Access Compliance Report

Public Rights-of-Way

(Curb Ramps)

Intersection ID: 28385	Main Street: COMMONS_CROSSING_DR	Cross Street: HIGHLANDS_CROSSING_DR	Location: SW
ADA ID: E26C98B2FCC6	Ramp Type: PerpDiag	Initial Pass/Fail: Pass	Overall Compliance: No
Severity Score: 22.5			
Codes/Mitigation Info/Possible Solution		Field Measurements/Component Compliance

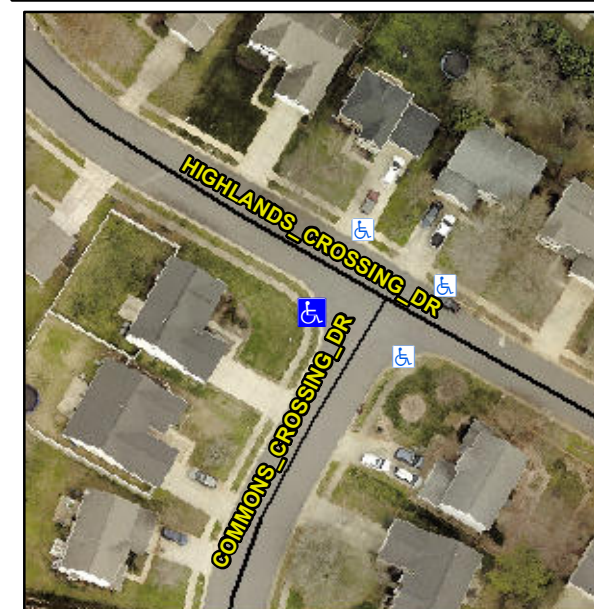
Not Found, R304.2.1, R304.2.2-Perp, R304.3.2-Para, R305, R302.7.2, R304.5.4

Compliance	Description	Data	Compliance	Description	Data
N/A	Ramp Length (in)	48.0	Yes	Ramp Slope (%)	5.2
Yes	Ramp Width (in)	60.0	Yes	Ramp XSlope (%)	1.0
N/A	Flare Type LT	Sloped	N/A	Flare Type RT	N/A
N/A	Flare Slope LT (%)	8.0	N/A	Flare Slope RT (%)	3.8
N/A	Flare Traversable LT?	No	N/A	Flare Traversable RT?	No
No	Landing Length (in)	47.0	No	DWS Provided?	No
Yes	Landing Width (in)	60.0	N/A	DWS Contrast?	No
No	Landing Slope (%)	2.6	N/A	DWS Length (in)	N/A
Yes	Landing X Slope (%)	1.3	N/A	DWS Full Width?	No
N/A	Landing Curb? (Y/N)	No	N/A	DWS Offset (in)	N/A
N/A	Shared Landing?	No			
Yes	Gutter Ponding?	No	No	Gutter Slope (%)	9.9
No	Gutter Lip Ht (in)	0.5	Yes	Gutter X Slope (%)	0.7
N/A	Painted X Walk1?	No	N/A	Painted X Walk2?	No
	X Walk 1 Direction	To SE		X Walk 2 Direction	To NE
N/A	X Walk 1 Width (in)	N/A	N/A	X Walk 2 Width (in)	N/A
	X Walk 1 Slope (%)	3.6		X Walk 2 Slope (%)	0.5
	X Walk 1 X Slope (%)	0.2		X Walk 2 X Slope (%)	1.4

N/A	Ramp inside XWalk1?	N/A	N/A	Ramp inside XWalk2?	N/A
	Road Slope (%)	0.0	N/A	Clear Space?	Yes
	Road X Slope (%)	0.6	N/A	Clear Space to XWalk (in)	N/A
Yes	Any Obstructions?	No	Yes	Storm Grate/Utility Hazard?	No
	Obstruction Type			Storm Grate/Utility Type	
		N/A			N/A
			Yes	Surface Condition? (G/P)	Good

Remove & Replace Curb Ramp With Two New Directional Ramps or Equivalent. Remove & Replace Gutter.
